Final Environmental Impact Report (Final EIR)

Los Angeles International Airport (LAX) Central Utility Plant Replacement Project

Responses to Comments and Corrections and Additions to the Draft EIR

October 2009

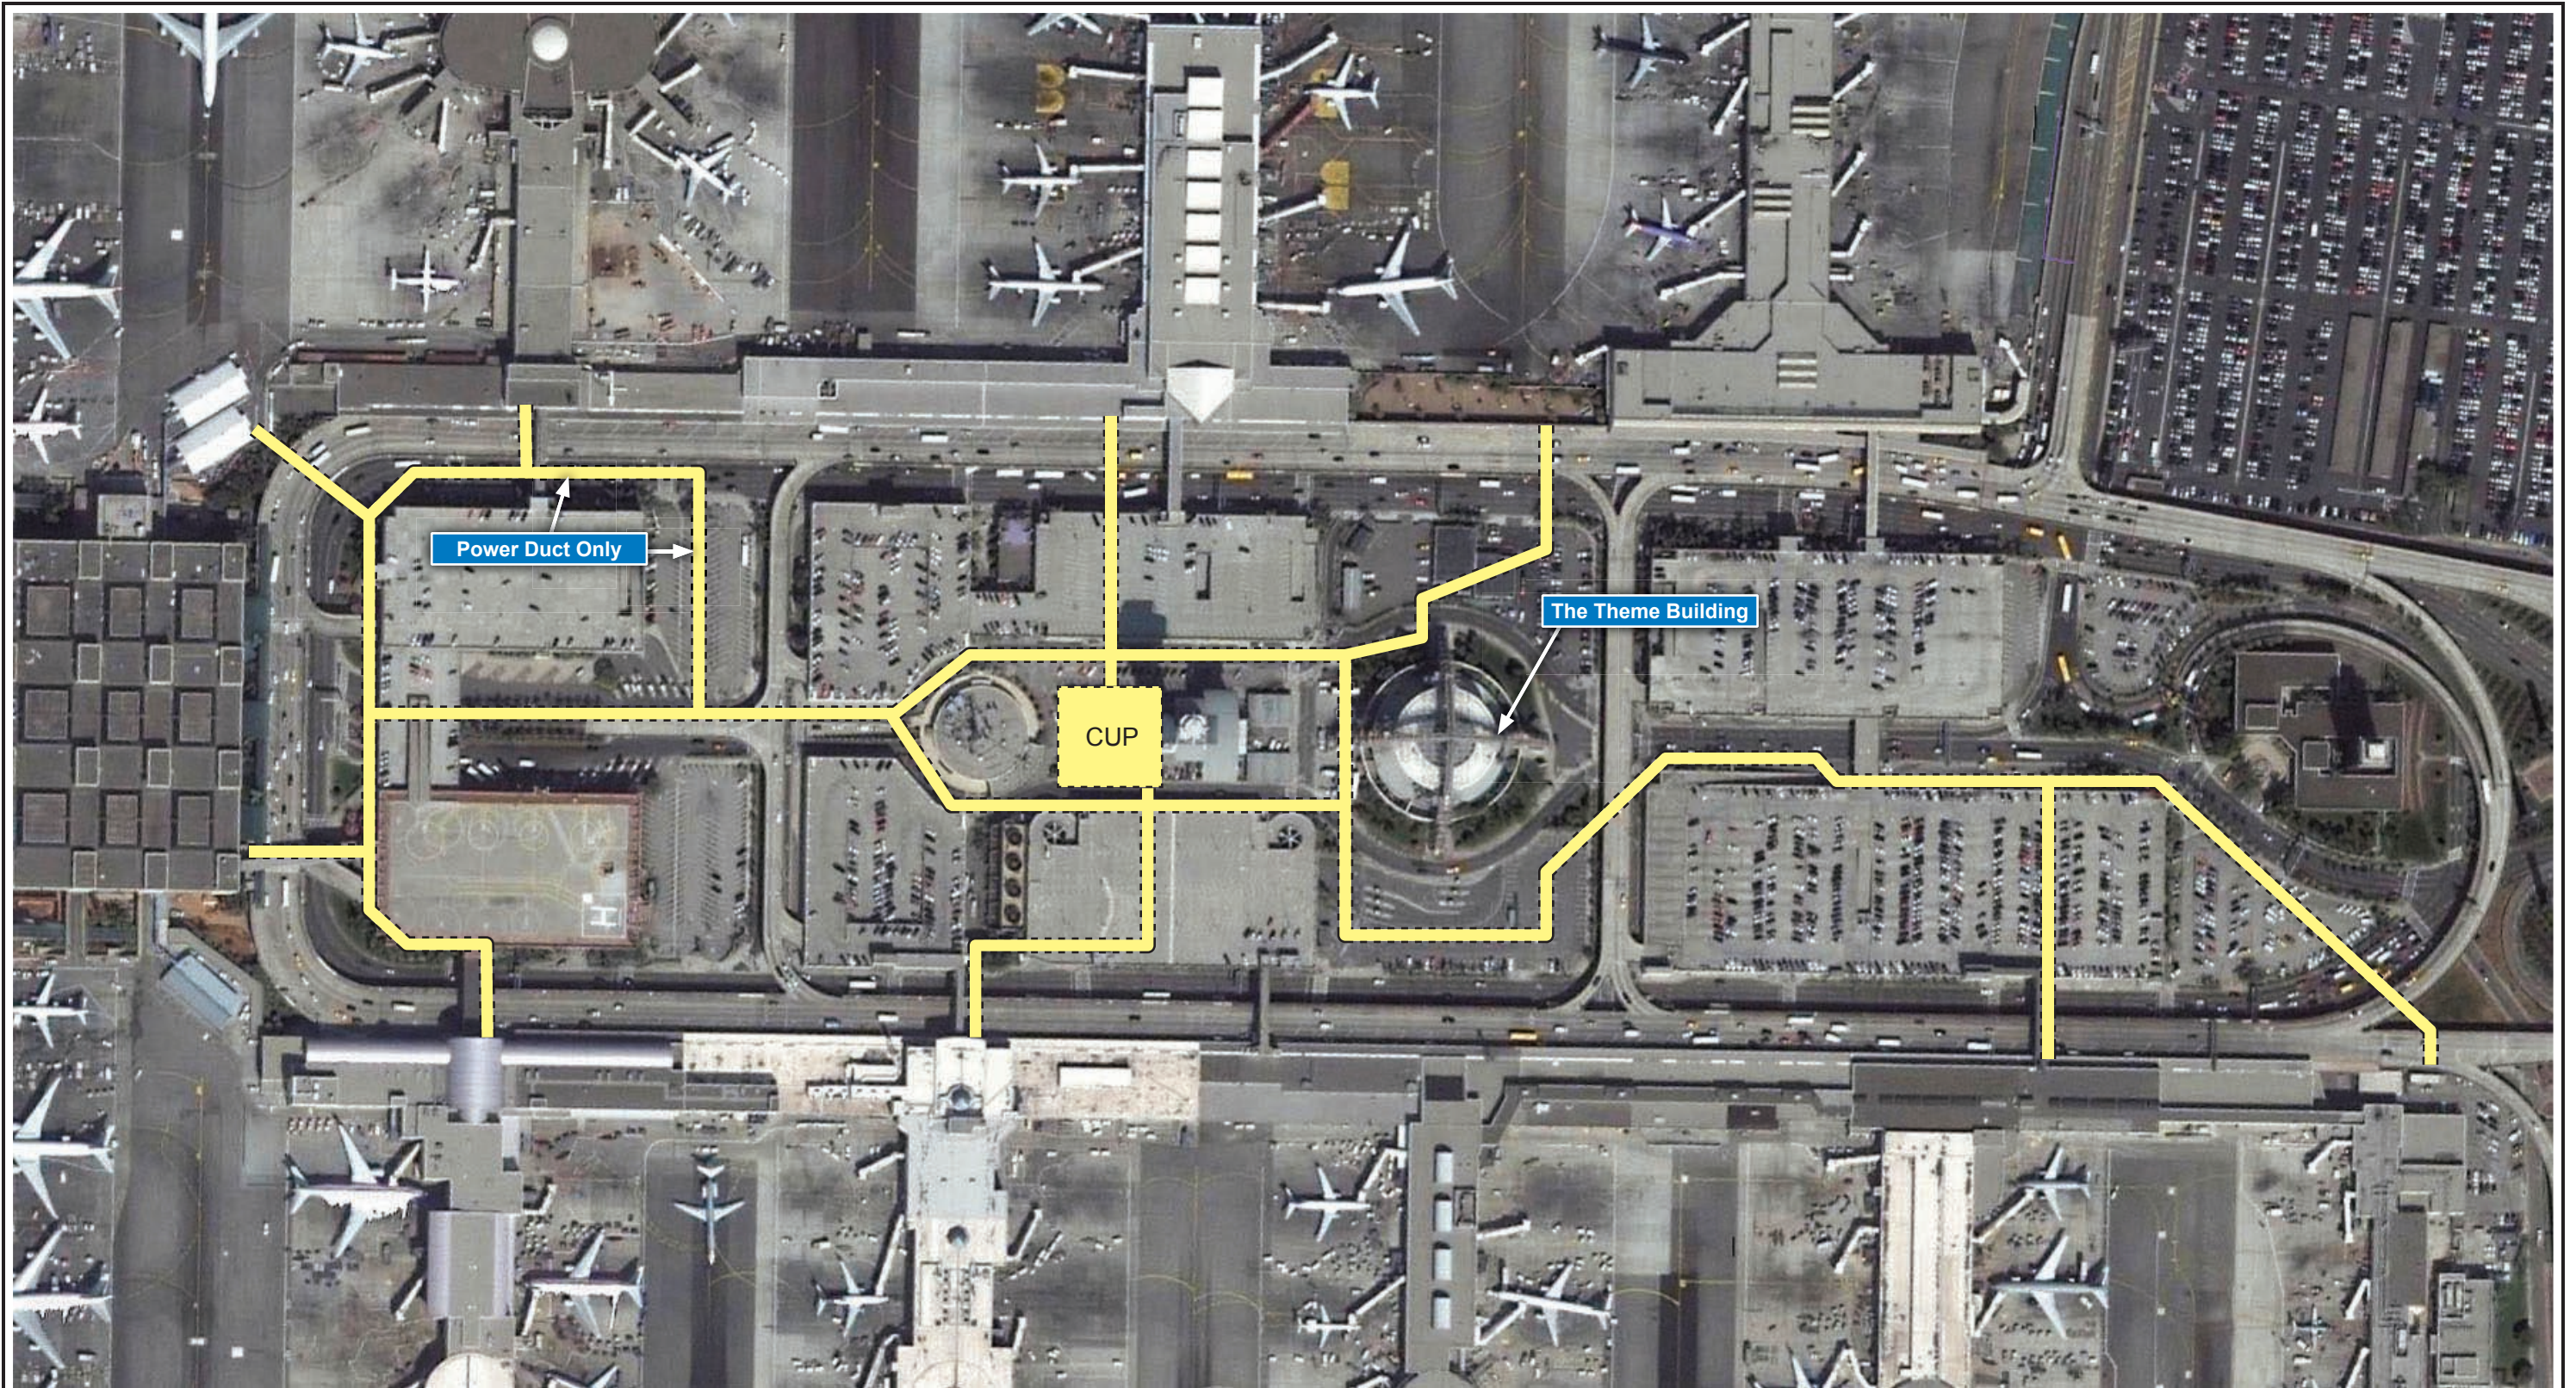
Comment: Assuming utilidors are chosen as the preferred implementation option, will they be enacted for use to all facilities supplied instead of the limited number shown in EIR drawings?

Response: The Utilidor in the general alignment shown in Figure 2-7 on page 2-21 in Section 2.4.5 of the CUP-RP Draft EIR would serve the same terminals and facilities currently served by the existing CUP. These include Terminals 1, 2, 3, 4, 5, 6, 7 and 8, Tom Bradley International Terminal, the Theme Building and Administration East. Figure 2-7 in the Draft EIR does not show a utilidor connection to Terminal 6 because hot water and chilled water for that terminal are supplied through pipes that extend from Terminal 7 (i.e., the utilidor connection to Terminal 7 would provide hot water and chilled water for both Terminals 6 and 7). Please also see Response to Comment CUP-PC00002-6.

4. Figure 2-7 on page on page 2-21 of the Draft EIR has been revised to reflect the utility line alignments including the water lines and power communication ducts. Please see the following revised figure.
5. The text of Section 2.4.8 Potential Off-Site Reclaimed Water Treatment System Sites on pages 2-20 and 2-23 of the Draft EIR is hereby revised as follows:

Figure 4.1-6

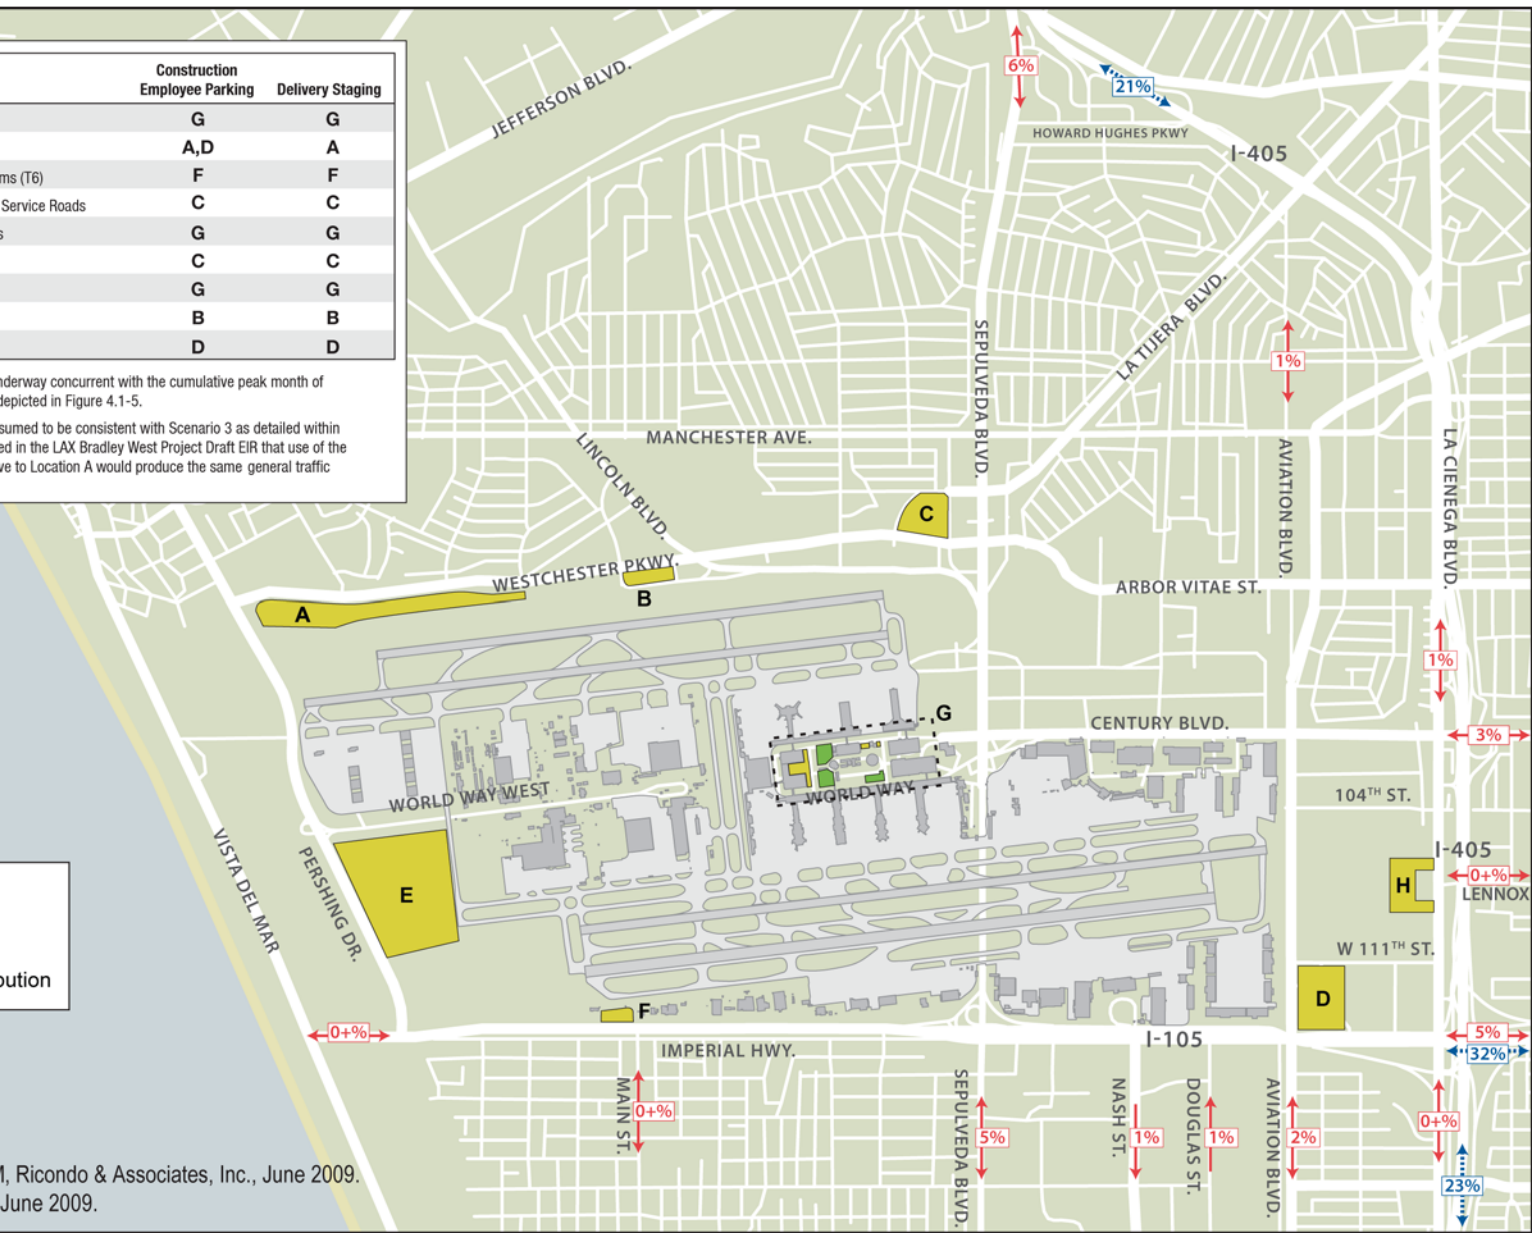
Comment: We are pleased to see that LAWA stated in the EIR introduction that, "Staging for construction equipment, as well as construction worker parking, would be located in surface parking lots within the CTA." We understand that LAWA has discarded plans for any use of parking accesses along the northern boundary, Westchester Parkway, including areas behind the existing Westchester Business District. If our understanding has changed, please note our unequivocal objections and we ask that you specify what your new plans are before project approval.

Response: As indicated by the commenter and as noted in Section 2.5 of the CUP-RP Draft EIR, all construction staging and parking associated with construction of the new CUP would be located within the Central Terminal Area (CTA). The CUP-RP construction would not use any construction staging areas in the northern portion of the airport off of Westchester Parkway. However, for purposes of evaluating cumulative construction-related surface transportation impacts, construction staging locations for other airport-related construction projects were considered in the CUP-RP surface transportation analysis. At

Response: Please see Response to Comment CUP-PC00001-2 regarding the use of construction staging locations for the CUP-RP and other LAX-related construction projects. As discussed in that response, no CUP-RP construction parking or staging would occur in the north area bordering Westchester. All CUP-RP construction staging and parking would be located within the Central Terminal Area (CTA). It should be noted that the board referred to by the commenter, which is a copy of Figure 4.1-6 of the CUP-RP Draft EIR, identifies the same construction staging areas for cumulative projects as did the analogous figure (Figure 4.3-6) of the Bradley West Project Final EIR, as amended in Chapter 3. No new construction staging areas have been added to this figure.

1. Figure 4.1-6 on page 4-39 of the Draft EIR has been revised to clarify that the Northwest Construction Staging Area is no longer proposed to be a primary contractor employee parking area for the Bradley West Project. Please see the following revised figure.
2. The following text is hereby added to the end of the first bullet on page 4-75 of the Draft EIR:
